TS-SSC 92-074
Gianni Tassotto
6/16/92

**CHANGE OF LOCATION OF VOLTAGE
TAP ON LOWER OUTER COIL OF SSC 50 mm
MAGNETS DCA322 and DCA323**

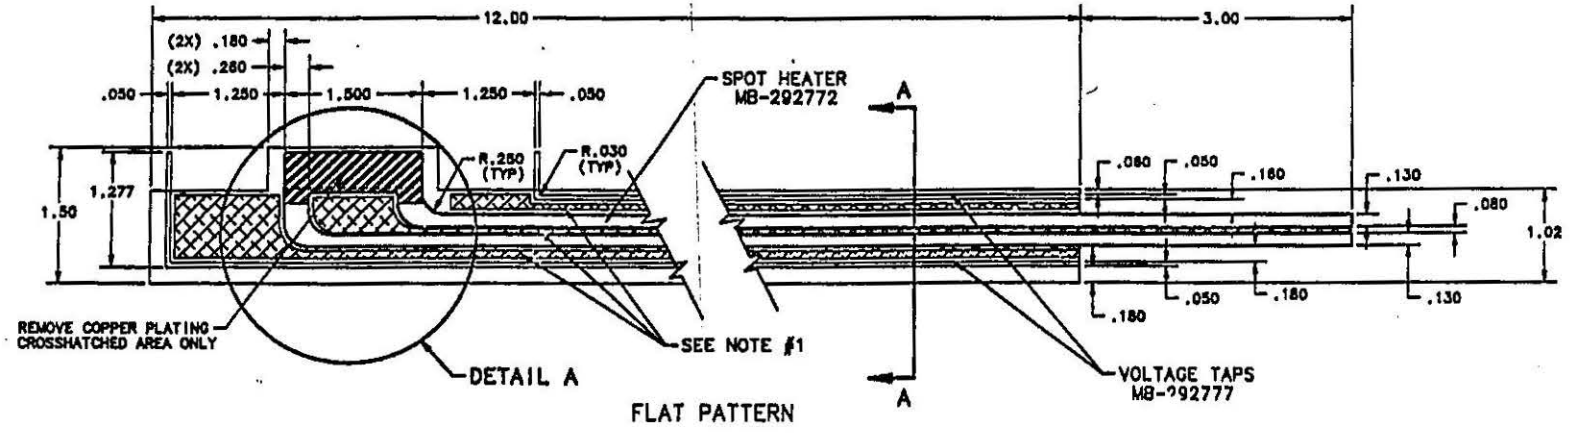
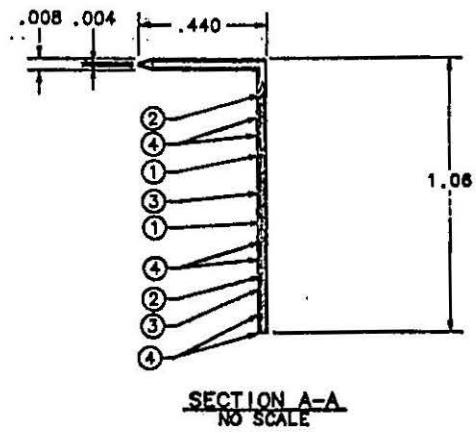
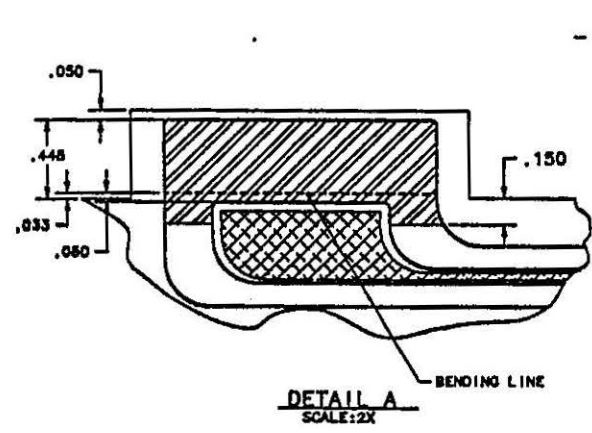
Technicians followed the set of guidelines already outlined in TS SSC92-250. Voltage tap OH was easier to install than 1A because there was no need to separate the turns with a nylon wedge. Also, on magnets DCA322 and DCA323, the thickness of the kapton sheet around the spot heater/voltage tap ass'y was changed to 0.001 inches.

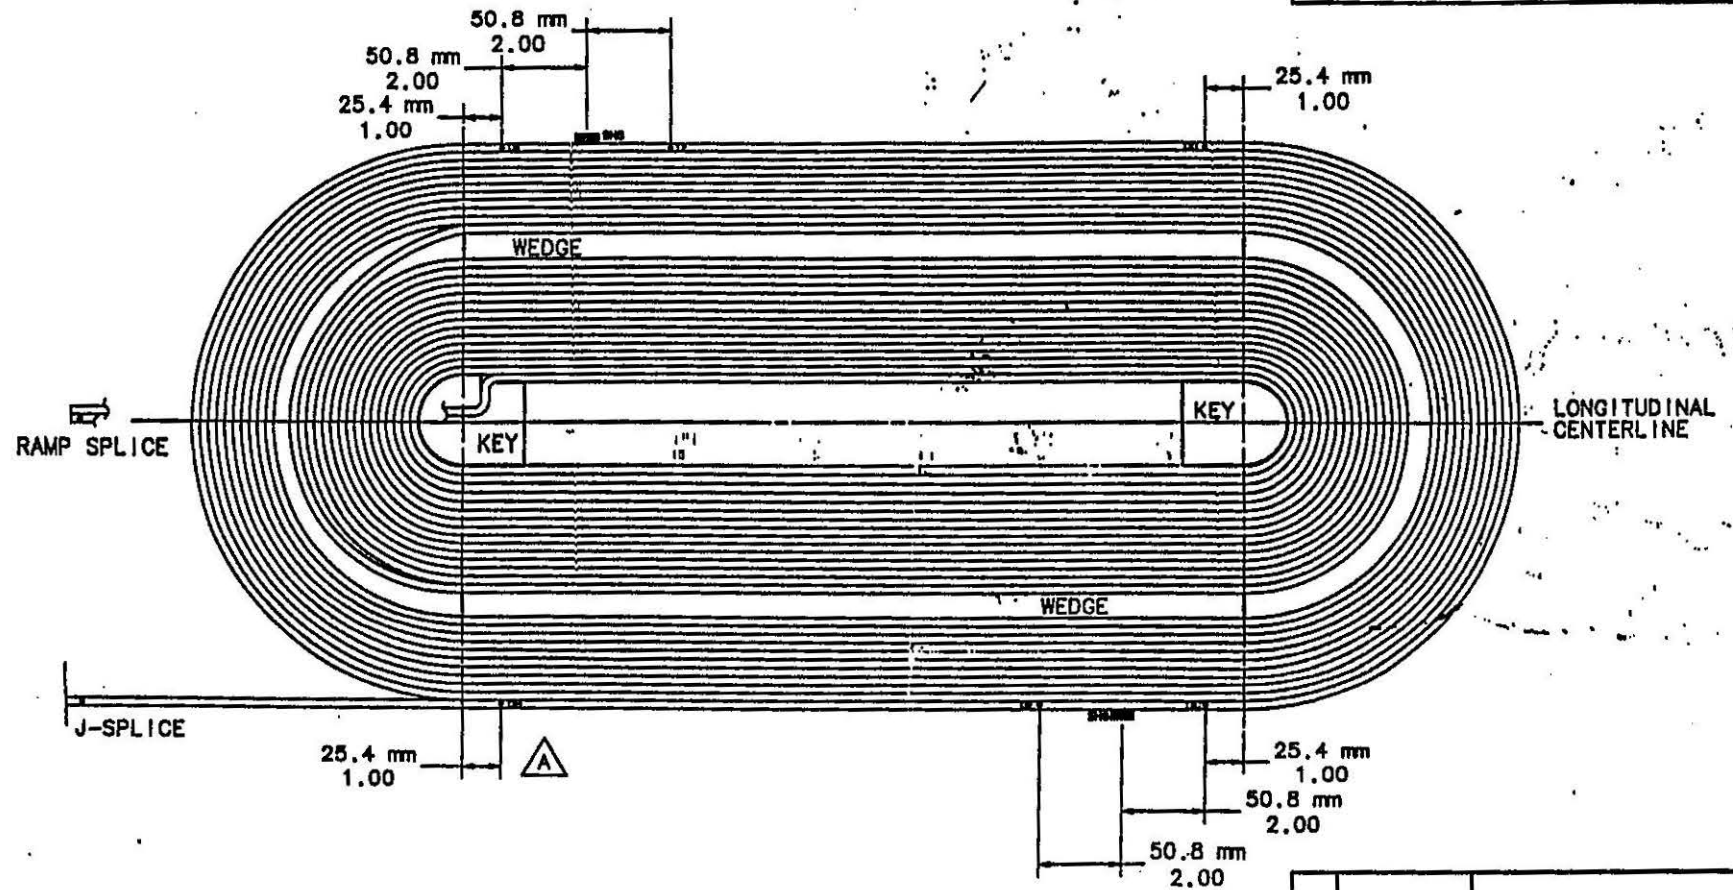
After A. Devred and J. Tompkins looked at DCA321 drawing about the location of voltage taps on lower outer coil (see drawing MC-292773), they suggested to change the location of voltage tap 1A at the end of the first turn and relocate it at the beginning of the first turn and, a few inches away from the quarter coil voltage tap C. This voltage tap is now labelled OH.

REV.	DESCRIPTION	DRAWN	DATE
		APPD.	DATE
A	RELOCATED VOLTAGE TAP (OH) OH WAS 1A ON DCA321	MTATE	4/30/92
		P.S.	5-1-97

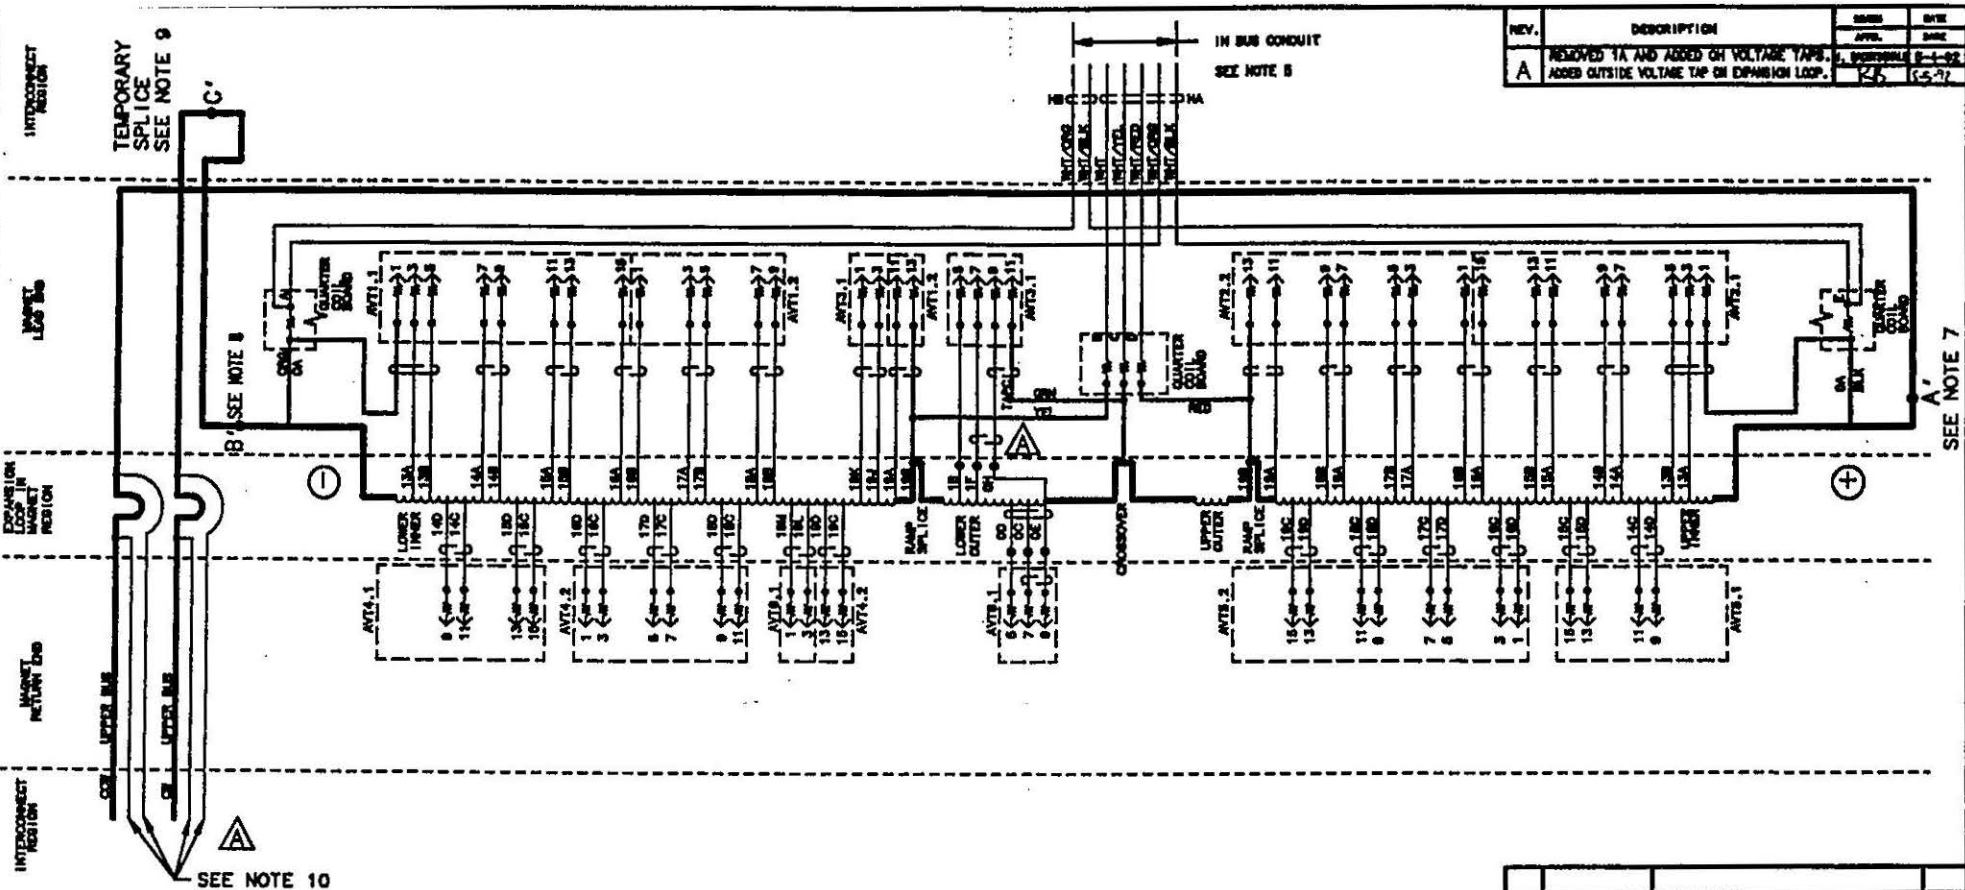
REV.	DESCRIPTION	ISSUE	DATE
A	REMOVED 1A AND ADDED OH VOLTAGE TAPS, ADDED OUTSIDE VOLTAGE TAP ON EXPANSION LOOP.	RLB	6-5-92
